MINUTES OF THE MEETING OF THE FRANKLIN MUNICIPAL PLANNING COMMISSION FEBRUARY 28, 2013

NAME OF PROJECT: Franklin Park PUD Subdivision, site plan (Apartments)
LOCATION: Northwest corner of East McEwen and Carothers
PROJECT DESCRIPTION: 329 dwelling units on 14.07 acres
APPLICANT: Brad Slayden, Ragan Smith
OWNER: Pat Emery, Spectrum Properties/Emery
PROJECT STAFF: Emily Hunter
TYPE OF REVIEW: Site Plan
RECOMMENDATION: ~~Deferral to the March 28, 2013 FMPC Meeting~~
Approval, with conditions

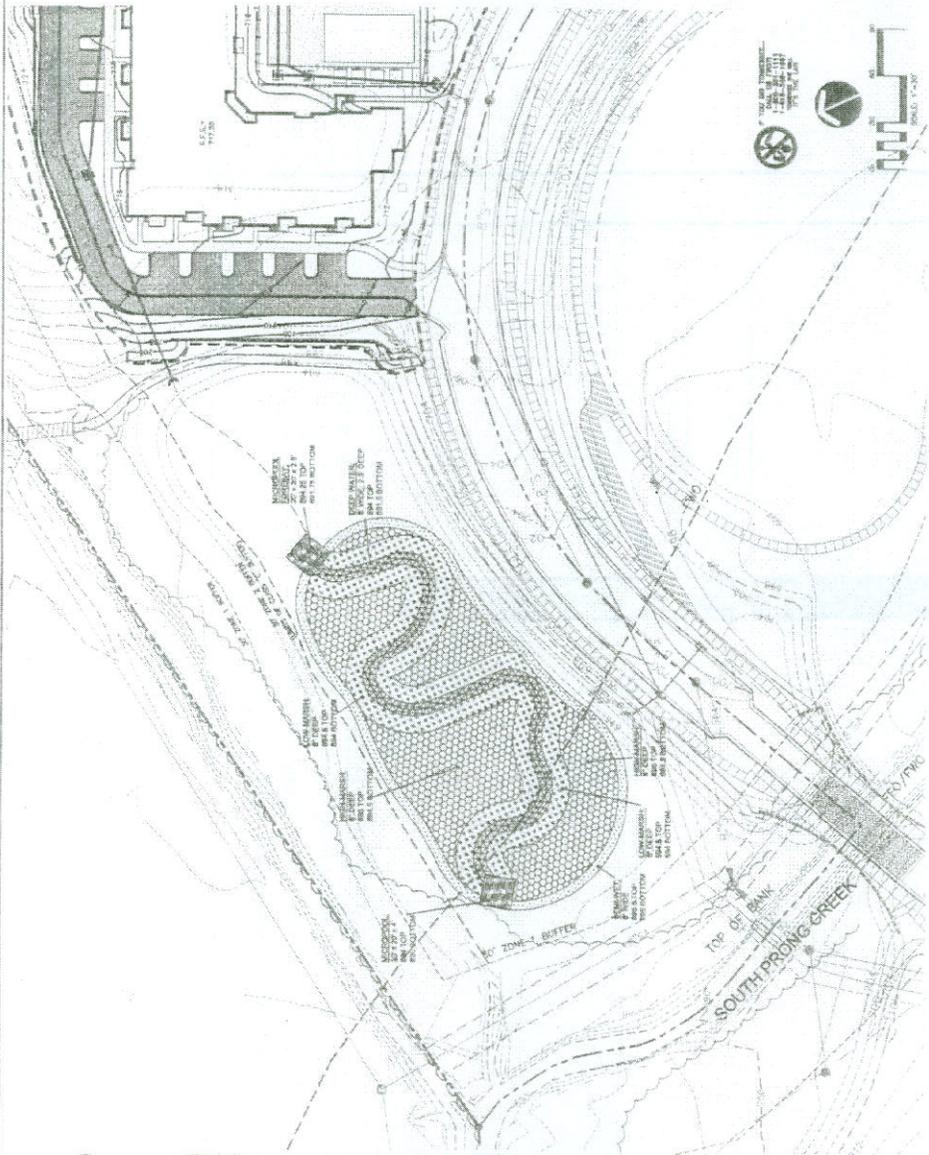
- The applicant shall revise the elevations shown for T.W. & B.W. for the retaining wall at the northwest corner of the property. The current elevations (708.8 & 707.7) do not appear to match the contours.

- Comparing the autoturn travel/driving path of fire department apparatus (C3.2) and design elements on sheet L107, there are multiple points of conflict and potential collision with fire apparatus and property. One such point is the area of proposed stainless steel bollards at the front entry doors which appear in direct line with the travel path of the autoturn template.

The apparatus travel path also appears to show a collision with the retaining wall during the backing motion.

- The applicant shall remove landscaping materials as shown on L306 that prevent access to and visibility of the building's fire sprinkler connection (fire department connection). As shown, there appears to be at least five shrub plants that would obstruct the visibility of the FDC and delay access to fire protection equipment.

- The applicant shall update the site data chart to remove the retaining wall height or revise with the full description of what is allowed, per the modification of standards. A single 16' wall shall not be permitted.

The applicant shall revise road design and/or provide adequate turning space for emergency and service delivery vehicles so as to distinctly reduce potential for collision and damage.

PRODUCT DESIGN: MANOR HOMES

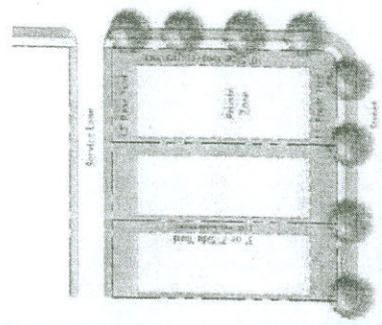
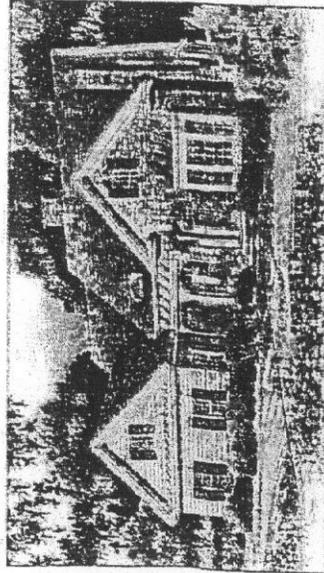
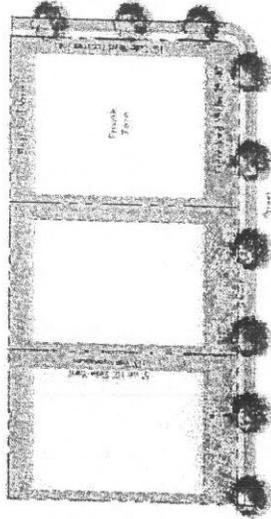
* **Design Modification Request**
 A waiver is requested from the garage door requirements set forth in the City of Franklin Zoning Ordinance, Section 5.3.5 (2)(d)(i) for side and rear loaded garages.

A waiver is requested from the garage door requirements set forth in the City of Franklin Zoning Ordinance, Section 5.3.5 (2)(d)(iv) for side and rear loaded garages.
